# CITY OF ALBUQUERQUE

RE: **Los Diamantes Subdivision  
Drainage Report, and Grading and Drainage Plan  
Engineer's Stamp Date 8-26-2015 (File: N09D013)**

RE: **Los Diamantes Subdivision**  
**Drainage Report, and Grading and Drainage Plan**  
**Engineer's Stamp Date 8-26-2015 (File: N09D013)**

**Re: Los Diamantes Subdivision  
Revised Engineers stamp date 8-24-15 (N09/D013)**

STANDARD GRATE DETAIL FOR INLET

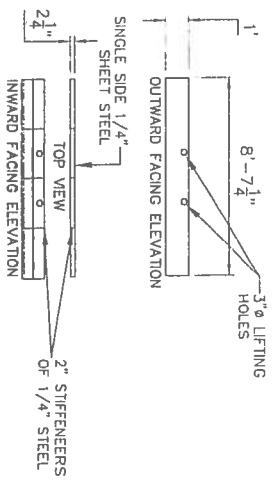
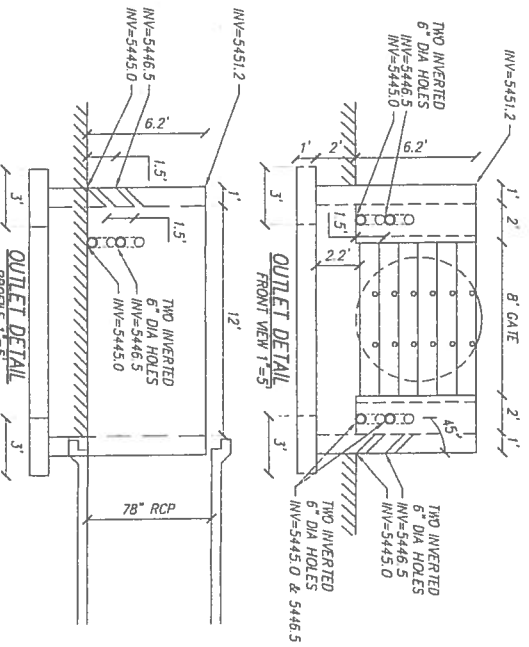
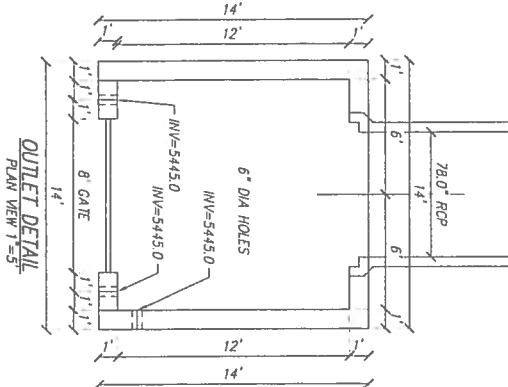
- d. Show details for the manhole/wier cover. This will be certified on the grading plan and not on the Work Order, since the pond is Private.
  - e. The emergency spillway for the pond (El. 108.0) appears to be lower than the sidewalk.

- d. **"Show Detail for the manhole/weir cover..."** Please see note 2 of your attached email dated 8/13/2015. The inlet/outlet structures are detailed on the grading plan sufficiently to show how they will work. In addition, a "Standard Grate Detail for Inlet" exhibit was added to the DMP for additional explanation.

## LOS DIAMANTES SUBDIVISION GRADING & DRAINAGE PLAN

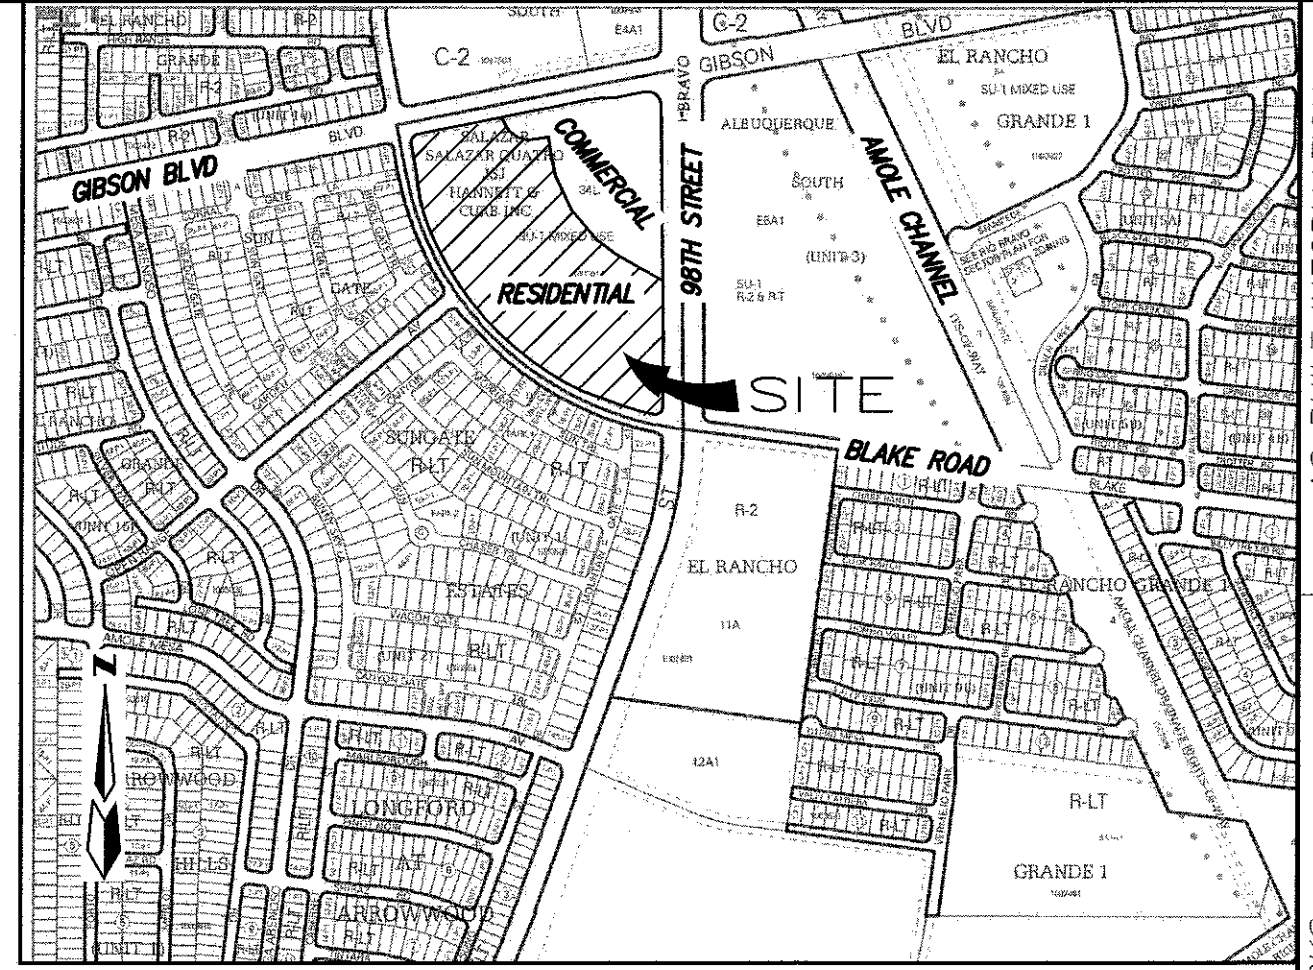
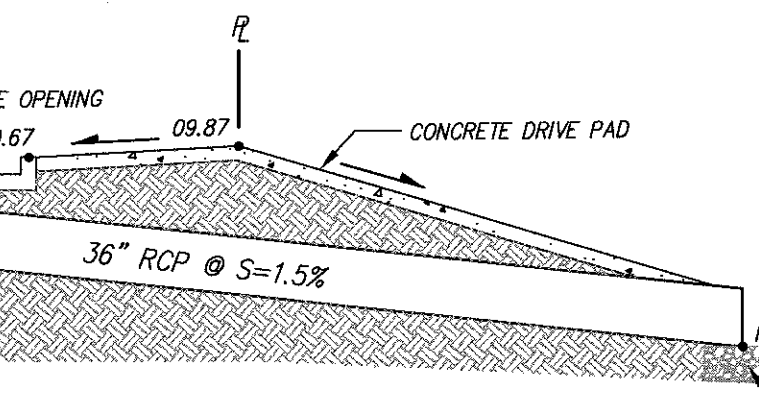
1. Temporary Pond on Tract A: Side slopes (2:1) must be stabilized with a more stable material. Per your email on 9/8/15 you will be changing it to a 3:1 slope with gravel mulch. This change must be reflected on the Engineer's Certified Plan.

1. Temporary Pond on Tract A: Side slopes (2:1) must be stabilized with a more stable material. Gravel mulch is not stable enough.

6. Temporary Pond on Tract A: Per DPM 22-5.I, retention ponds must be designed for the 100 yr-10 day storm. Side slopes greater than 2:1 must be stabilized somehow and shown on the plan.

8. Since the pond will be constructed off the grading plan provide an enlarged plan of the pond.
  - a. Detail the emergency overflow from Del Timbre Lane to the pond. Show that flows will not flow thru emergency overflow before being collected by the inlet. Is it hardscaped? Is there a drive pad? Or standard Curb?

- b. No calculations were included showing that the WSEL of the cattle guard/grate with a 50% clogging factor would not encroach into private lots.
  - c. Provide construction details of the cattle guard grate inlet as this is not a Work Order item. Revise keyed note A as such.

**stabilized...** The pond is designed for the 100yr-10day storm as required. Additional calculations have been added to Appendix D in the DMP to clarify the design. A note has been added to the grading plan stating "2:1 slopes to be stabilized with gravel mulch."

8. **"Since the Pond will be constructed off the Grading Plan...."**
  - a. **"Detail the emergency overflow from Del Timbre Lane to the pond. Show that flows will not flow through the emergency overflow before being collected by the inlet..."** An additional detail was added to the plan that shows how the inlet structure on Del Timbre Lane will work. Additional calculations are included in Appendix C of the DMP that shows that the developed flows will be captured by the inlet and will not overtop the standard curb. In addition, directional flow arrows and spot elevations have been added to the drive pad to clarify the drainage path for the emergency overflows. The depth of these flows are lower than the adjacent house pads.

- b. **"No calculations were included showing that the WSEL of the cattle guard/grate with a 50% clogging factor would not encroach into the private lots."** The MWSEL with a 50% clogging factor is 109.82, and the lowest pad is 110.90. Therefore the runoff will not encroach onto the private lots. Please see calculations in Appendix C of the DMP.

- c. **"Provide construction details of the cattle guard grate inlet as this is not a WO item..."** Please see note 2 of your attached email dated 8/13/2015. The inlet/outlets structures are detailed on the grading plan sufficiently to show how they will work. All calculations are contained in the DMP.

- e. **"The emergency spillway for the pond (El. 108) appears to be lower than the sidewalk"** The elevation of the emergency spillway had been raised to 108.40. In addition, the location emergency spillway had been slightly adjusted towards the eastern corner so that the emergency spillway elevation of 108.40 is above the sidewalk.
